References: NRC Review Comments on Fermi 2 Emergency  
Plan, March 1981, dated July 6, 1981

Subject: Enrico Fermi Atomic Power Plant, Unit 2  
NRC Docket No. 50-341  
Radiological Emergency Response Plan

NRC REVIEW COMMENTS  
FERMI 2 RADIOLOGICAL EMERGENCY RESPONSE PLAN

BLOCK DIAGRAM OF PROPOSED  
METEOROLOGICAL DATA ACQUISITION SYSTEM

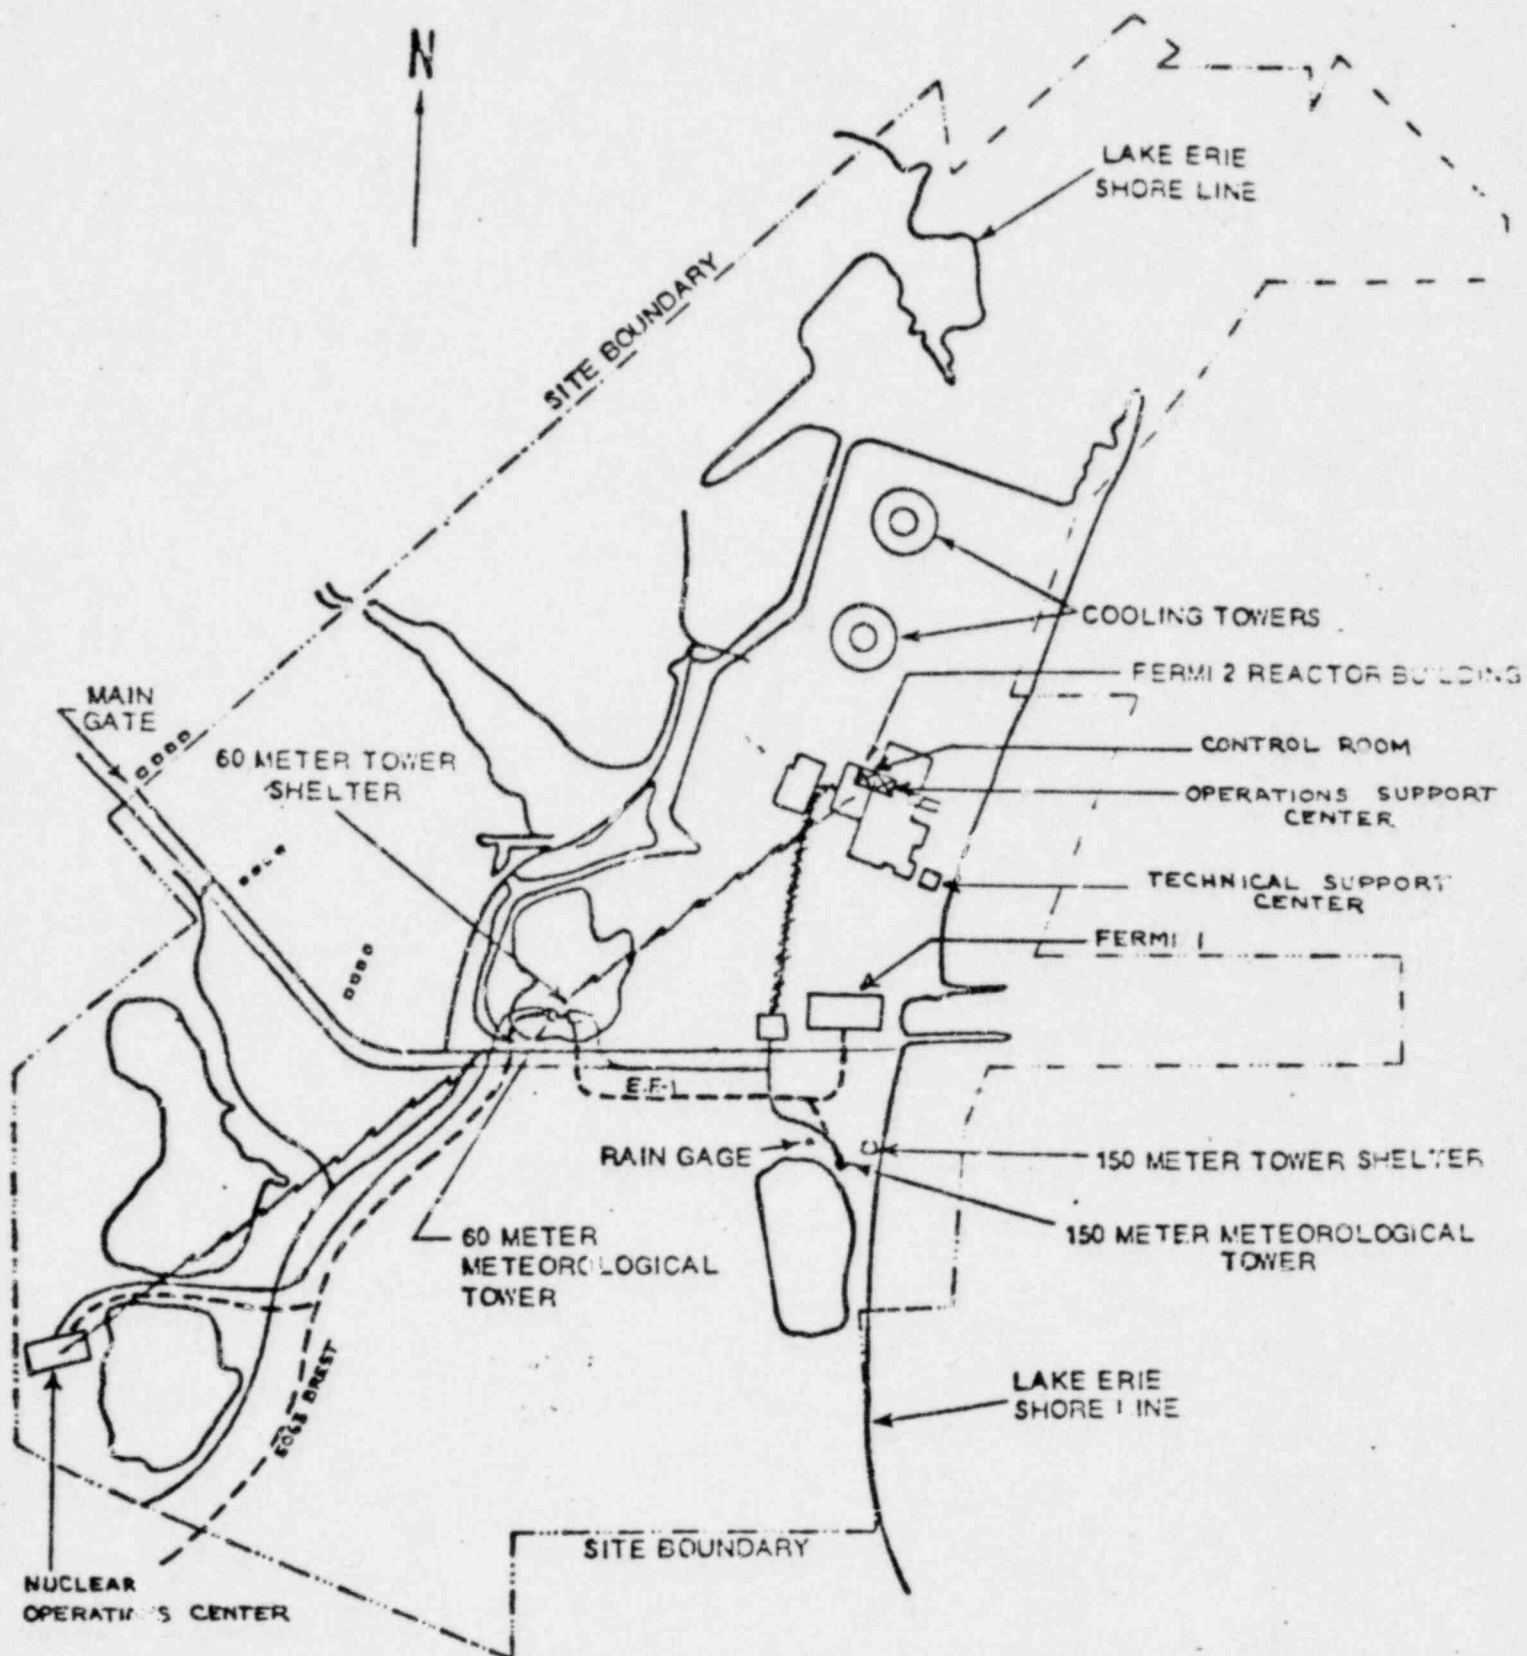
- H.5. Provide a description of the meteorological instrumentation and procedures as identified & in Appendix 2 of NUREG-0654, Rev. 1 and the provisions to obtain representative real-time meteorological information from other

Meteorological instrumentation is described in Appendix 1 to these responses.

A backup system will consist of wind speed, wind direction, and sigma theta mounted at the 10-meter level of the 150-meter tower presently onsite. Tables H-1, H-2, and H-3 indicate the parameters measured, the sensor descriptions, and the signal conditioners, respectively. Figure H-1 shows a block diagram of the modified system. This is subject to change as design progresses.
